**GOVERNMENT OF THE DISTRICT OF COLUMBIA
DEPARTMENT OF TRANSPORTATION**

MEMORANDUM

DATE: October 10, 2017

SUBJECT: ZC Case No. 17-08 – 601 50th Street NE, Providence Place

Figure 1 – Site Design and Access (Source: CTR, Gorove/Slade, Figure 9, August 21, 2017)

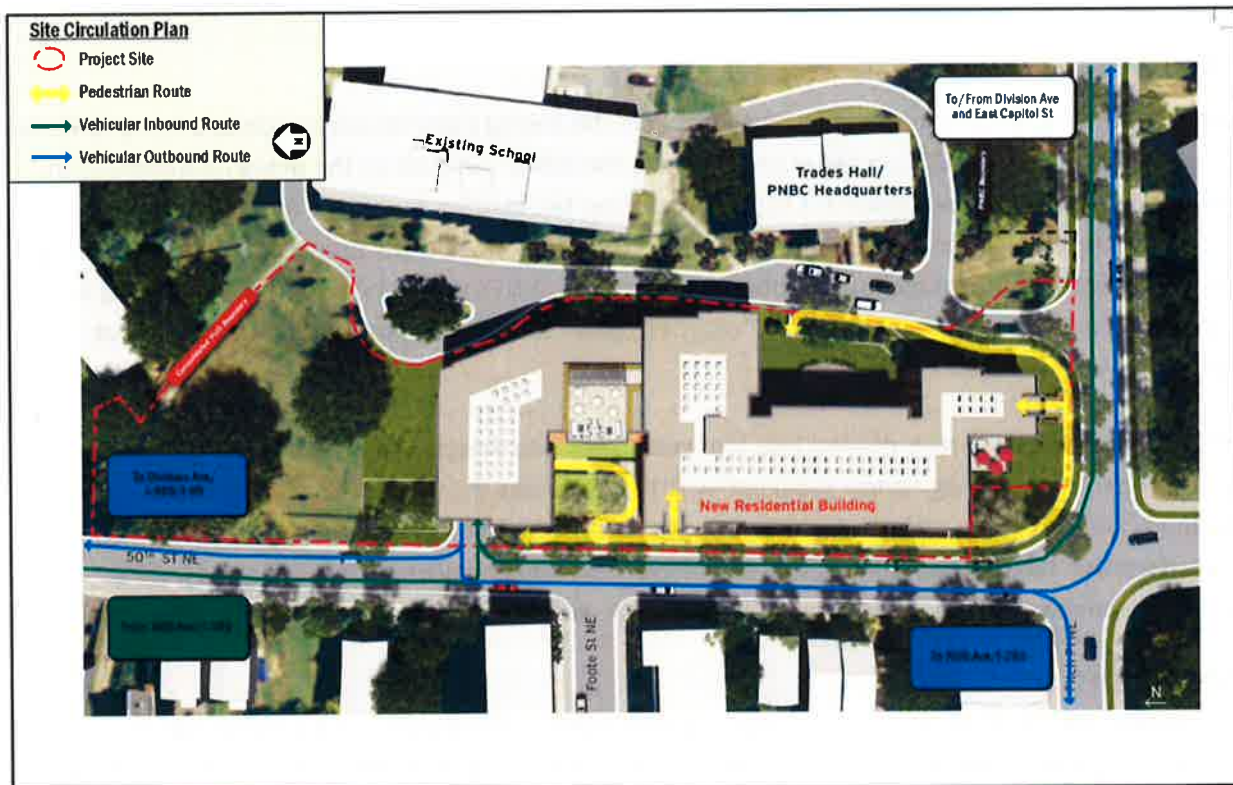
The Applicant proposes vehicular and loading access from a curb cut on 50th Street NE to south of the site. While DDOT’s preference would be for vehicle access to take place from the rear, DDOT has no objection to the proposed curb cut given the steep elevation changes on site. The Applicant is proposing a curb cut that does not meet DDOT’s standards for 60-foot offset from the adjacent intersection which could create access concerns relating to sight distance and crosswalks at Foote Street NE. The Applicant explored alternative curb cut options that were undesirable from a public space perspective and also created safety concerns. While DDOT prefers a garage entrance that lines up with Foote Street NE, DDOT does not object to the proposed site access given the grade limitations of the site and the sight distance analysis provided by the Applicant. Curb cuts concerns will be addressed at permitting and Public Space Committee approval is needed for the curb cut particularly since it does not meet DDOT standards.

Primary residential access is proposed along Fitch Place NE and auxiliary entrances are proposed on 50th Street NE and through a rear door located on private property, on the PNBC campus. Long-term bicycle parking is proposed in the parking garage and can be accessed via 50th Street NE.

Figure 4 – Pedestrian Facilities (Source: CTR, Gorove/Slade, Figure 24, August 21, 2017)

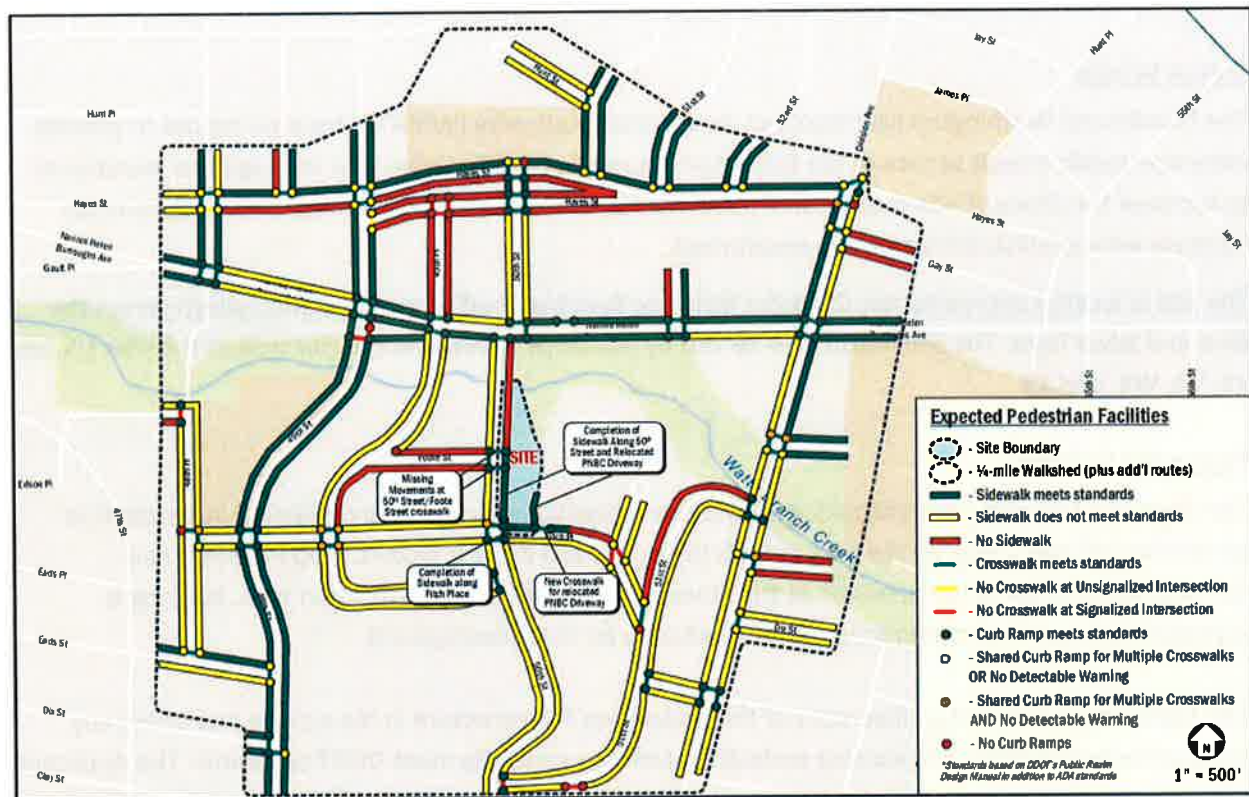
Preliminary site plans show improved pedestrian facilities surrounding the site, as shown in Figure 4. The Applicant is proposing to meet DDOT sidewalk standards. DDOT prefers a 6-foot wide sidewalk and 4-foot wide tree box to extend the building length along 50th Street NE and along Fitch Place extending from the intersection of Fitch Place NE and 50th Street NE to Nannie Helen Burroughs Avenue NE. The proposed sidewalk along 50th Street NE extends to Nannie Helen Burroughs Avenue NE, the primary connection to the bus stops. The Applicant is proposing a connection to the bus stops along Nannie Helen Burroughs Avenue NE which DDOT finds appropriate. The Applicant also proposes to continue the sidewalk internal to the site along the existing drive rather than terminating it at the building's edge.

This sidewalk will connect to the campus' existing sidewalk network and provide access to the Marvin Gaye Trail as well.

The CTR proposed a crosswalk at 50th and Foote Streets NE. Given the intersection has sight distance concerns, a crosswalk should not be implemented.

The Applicant is also proposing to install a curb ramp on the northeast corner of the Fitch Place NE and 50th Street NE intersection. DDOT also recommends improving the curb ramp at the northwest corner to complete intersection connectivity.
